5. Design changes, EIS clarifications and additional information

5.1 Design changes

NORTHERN SYDNEY FREIGHT CORRIDOR

EPPING TO THORNLEIGH

Figure 5.4 Development plan showing visible extent of convict-built stone causeway

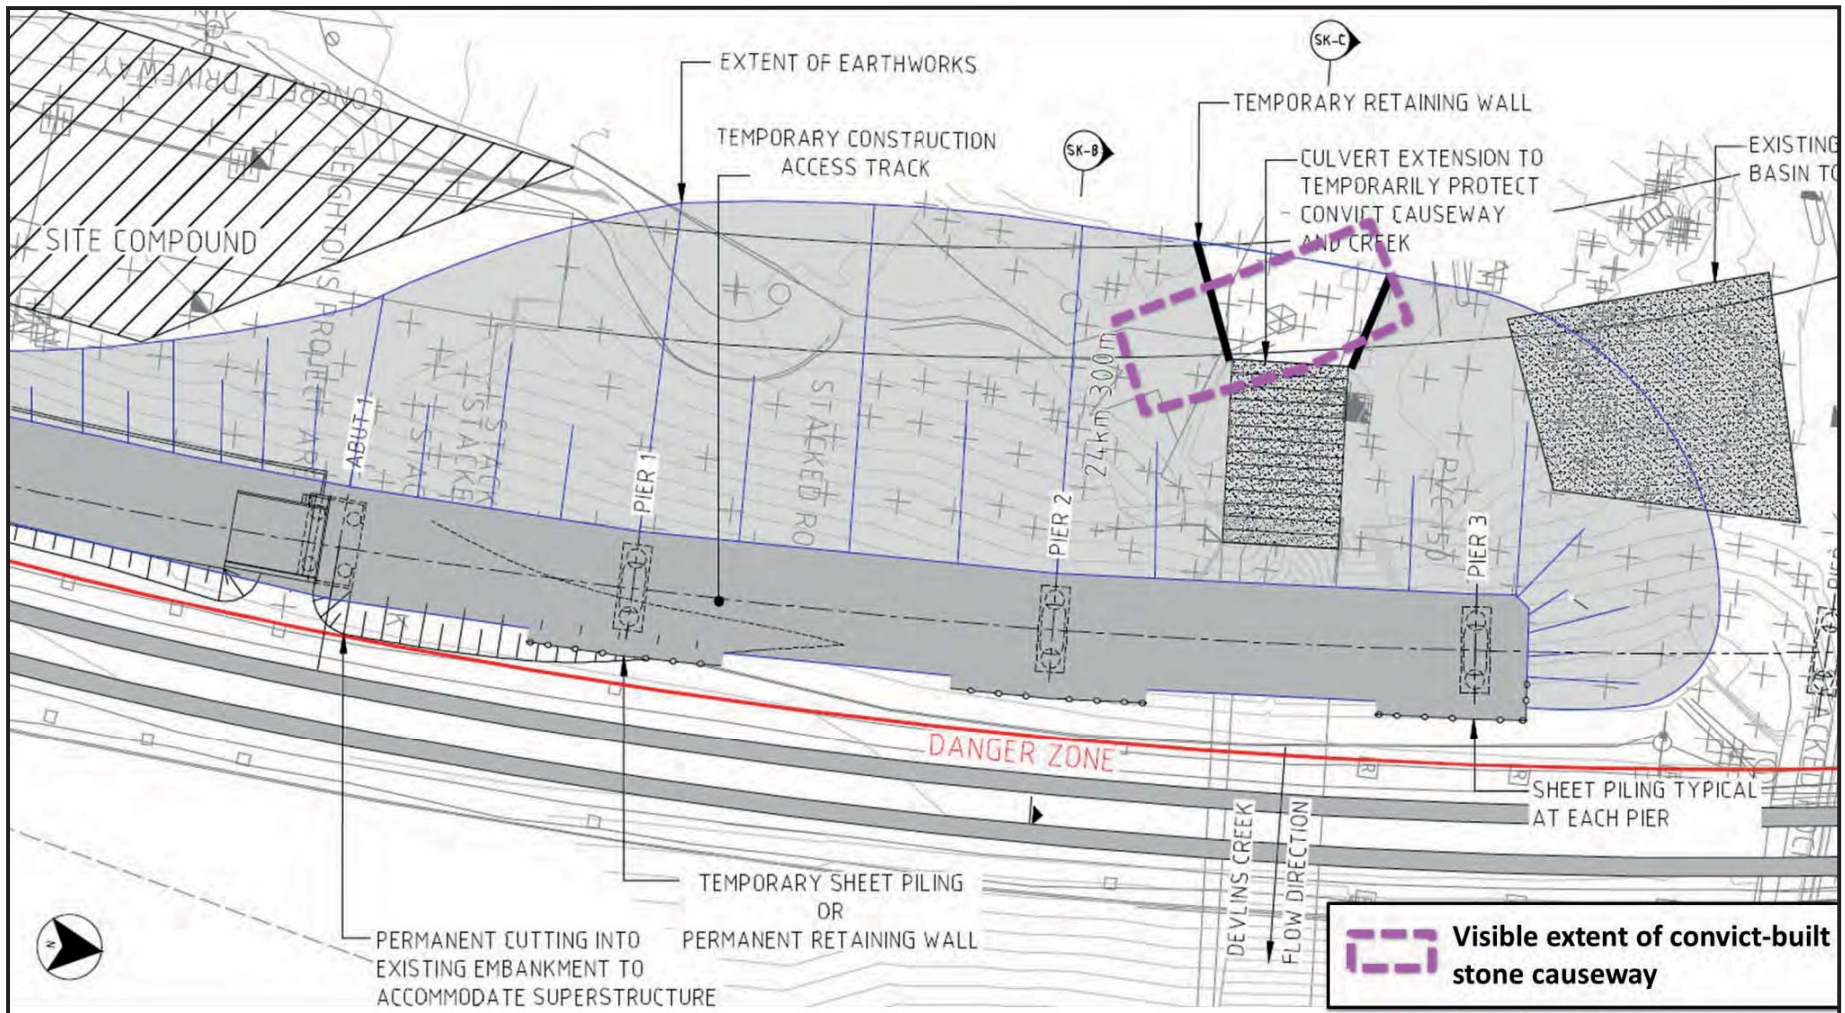
To enable the construction of the proposed M2 Motorway overbridge, a temporary embankment is required to be built, which would slope downwards to the west and north (shown as a light grey shaded area in Figure 5.4). Part of the convict-built stone causeway would be protected from the construction of this embankment by a temporary extension of the Devlins Creek culvert over a section of the causeway and the construction of two temporary retaining wing walls extending from the western end of the culvert. The temporary culvert would be constructed from a series of precast concrete arch units, and the proposed embankment would extend over the culvert. The retaining walls may consist of reinforced soil walls.

However, some parts of the convict built causeway would be located outside the area protected by the proposed culvert and retaining walls (as shown in Figure 5.4). It is assumed that these parts of the causeway would be covered with fill as part of the construction of the embankment. The fill would be temporary and, provided that the causeway was covered with plastic sheeting before the fill was placed on it (so that the fill could be easily removed following the completion of works), it is unlikely that there would be any permanent impacts to this heritage item. A revised environmental management measure (P.10) has been included in Chapter 6 of this report to reflect this requirement.

Three new environmental management measures (measures P.7, P.8 and P.10) have been included in Chapter 6 of this report to further manage the potential construction impact to the Devlins Creek causeway.

Figure 5.5 Extent of proposed construction works in the vicinity of Beecroft Station

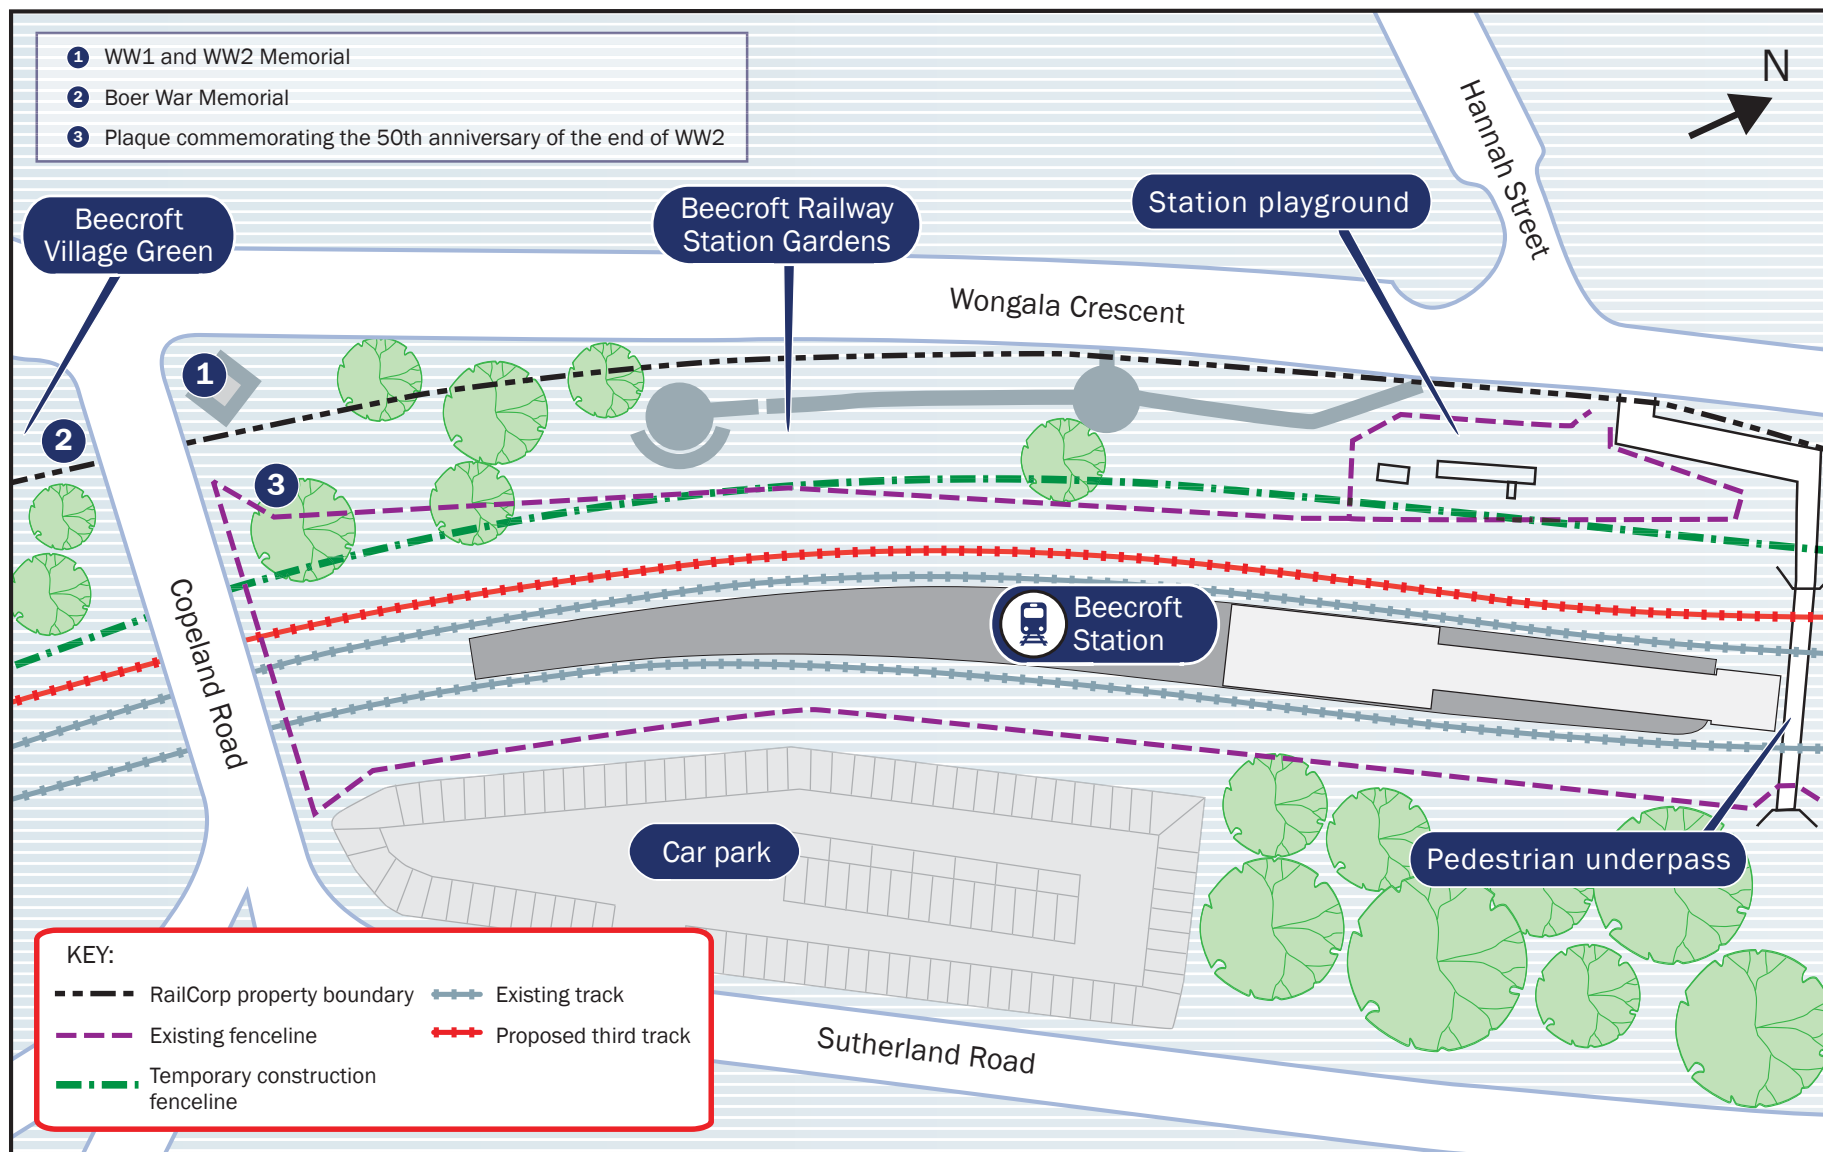
Subject to detailed design, the worst-case scenario is expected to encroach into the gardens and playground by up to 3 metres. This would vary along the length of gardens and would be much less in some areas. The encroachment on the Beecroft Station Gardens is minimal and is unlikely to impact on the existing use of the area. Figure 5.5 below illustrates the worst-case scenario.

Vegetation along the existing fence line would need to be removed. Options for revegetation to provide screening between the playground and the new track would be investigated and detailed in the proposal's urban design and landscape plan. This plan would be developed in consultation with Hornsby Shire Council and made available to the community for comment (refer to environmental management measure C.1 in Chapter 6 of this report for more detail).

The playground equipment would not need to be relocated, however, Transport for NSW are investigating a suggestion by Hornsby Shire Council to temporarily or permanently relocate the playground (refer to Transport for NSW's response to Item T.28 in section 4.4.2 of this report). It is thought that users of the playground might appreciate relocation to a location less impacted by construction activities. Further investigation and consultation with regard to this matter would be undertaken during detailed design.
